GA PLAN PROPOSED LEVEL 03

OUR TOWN HALL PROJECT

20210915 - Condition 11n - Staircase removal details - Report

Taken from OTH-PUR-TH-03-DWG-A-0379

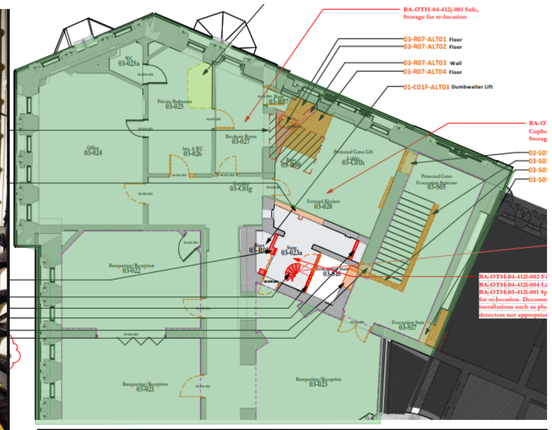
Spiral - wrought iron
it has been previously adapted not intact as stated by Purcell
The proposal is for it all being removed the reason for the removal is this is a strategic locations for fire egress staircase linking L07-06-05-04-03 , this hasn't changed ambition to reuse in the project - alternatively will go through the BAWG
Noted: this is not a change from the application

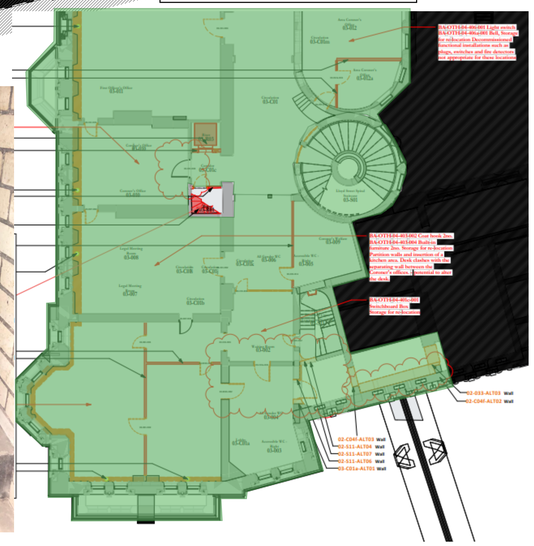
Proposed new riser - R01
The existing stone embedded into masonry - cantilevered stone treads - abandoned use as stairs in recent history. This is a strategic new riser location, utilising existing vertical riser in the building rather than creating new intervention.This is providing key new services to the state rooms. In addition its Proposed drainage route for new WC and welfare stacks in areas where previously there was no provision.

The proposal to re-use treads where possible however greater investigation of condition required on removal

Noted: this is not a change from the application

Taken from OTH-PUR-TH-04-DWG-A-0382

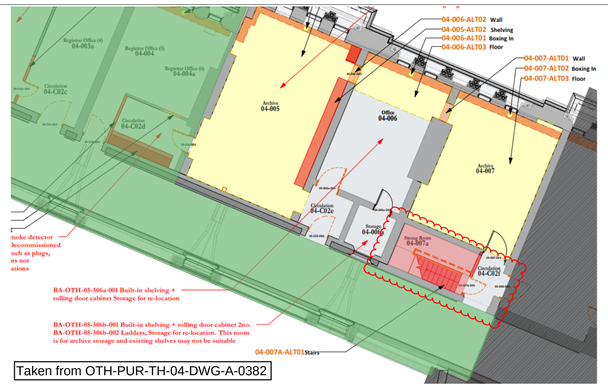
Proposed new strong room - for Registrars

The removal of this stair case has been coordinated with the project and the new archive store , this is a highly secure environment. The current proposal is that L04 to L06 staircase will be removed. Its noted that the staircase can't be retained in-situ due to the shelving that the registrars use these are fixed parameters that the design team have had to work to. The location of the strong room has been coordinated with the Registrar's and the OTH project, this is outlined in the HIA. The proposal for this staircase once removed is for it either to be donated the local timber charity that the project are working closely with or for parts to be reinstated as like the new jury court .

Noted: this is not a change from the application

Taken from OTH-PUR-TH-04-DWG-A-0382

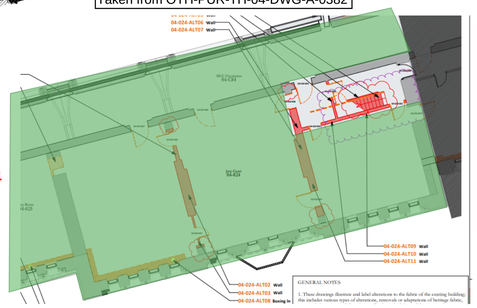
Proposed new Jury Court - for Coroners

The removal of this stair case has been coordinated with the project and the coroners. The current proposal is that L04 to L06 staircase will be removed. Its noted that the staircase can't be retained in-situ due to the requirements of the jury court. The location of the Jury Court has been coordinated with the coroners and the OTH project, this is outlined in the HIA. The proposal for this staircase once removed is for it either to be donated the local timber charity that the project are working closely with or for parts to be reinstated(L06) .

Noted: this is not a change from the application

Taken from OTH-PUR-TH-04-DWG-A-0382

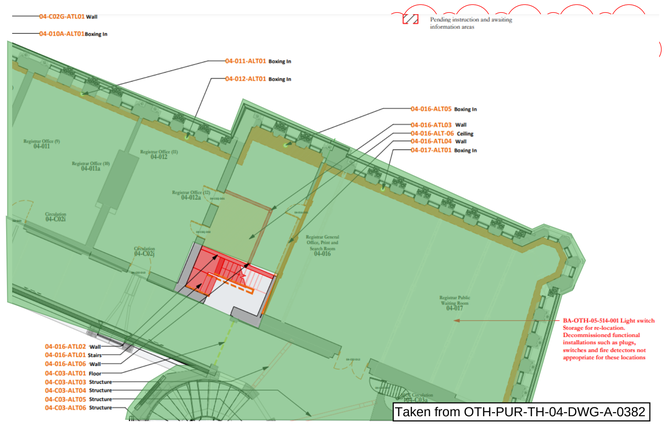
Proposed new circulation space

This staircase is no longer needed as at L06 this is now the main egress route to cooper core. Purcell note that this is very domestic not very significant stair
The staircase is same as 04-19c modern and has been reviewed with the LPA. The timber is to be donated to touchwood, Purcell are not proposing to be reused
Noted: this is not a change from the application

Taken from OTH-PUR-TH-04-DWG-A-0382

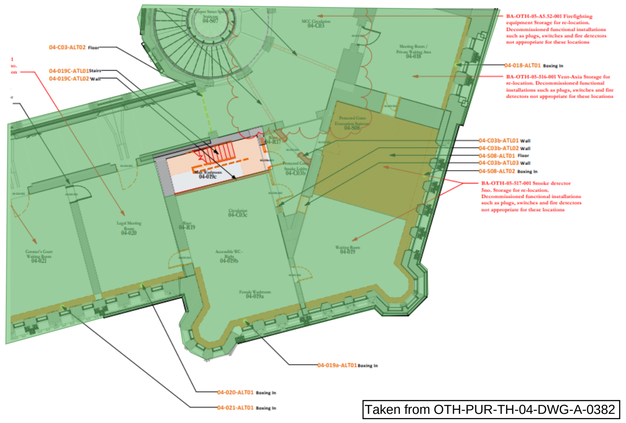
Proposed new toilets.
This staircase is no longer needed in the fire and access strategy in addition more compliant neighbouring routes. This is strategic location for stacked bathrooms and this footprint valuable which result in less impact to the building. The staircase is same as 04-16 modern and has been reviewed with the LPA. The timber is to be donated to touchwood, Purcell are not proposing to be reused
Noted: this is not a change from the application
